Subject: Class II Permissive Change for FCC ID: O4O-EYFPA

We would like to request a Class II Permissive change for FCC ID: O4O-EYFPA.

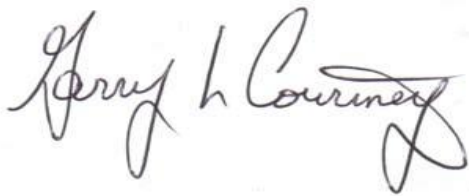
Battery voltage increased from 18V to 21.6V.

Motor winding changed to accommodate higher voltage, from ($\phi 1.1 \times 6T$) to ($\phi 1.1 \times 5T$).

The printed circuit board and circuitry remain the same.
